TECHNICAL MEMO

PRODUCT NAME: N4004(S), N6006, F401(s), F601 series camera
SUBJECT: Countermeasure of broken hook in camera back.

Fig 1

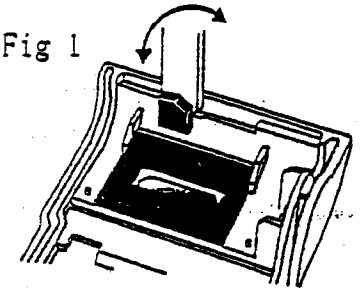
1) Insert the bottom of tweezers into clearance in the back of broken hook. (Refer to figure 1)

Fig 3

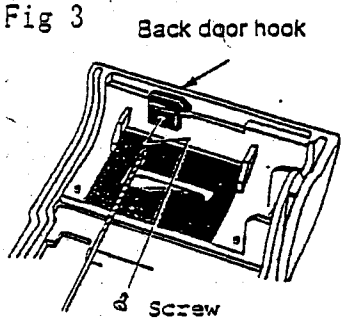
3) Spread Crazy Glue on the end face of broken part of hook, and mount a back door hook. (Refer to figure 2 and 3)

4) Confirm the fitness of opening and closing condition between the camera body with this condition. If there is no problem, open a tapped hole **a little** by drill, its diameter 1.7mm.

5) Adjust to the center of the hole, which was opened at process 4), and open a tapped hole by drill, its diameter 1.35mm then mount a screw. (Refer to figure 3)
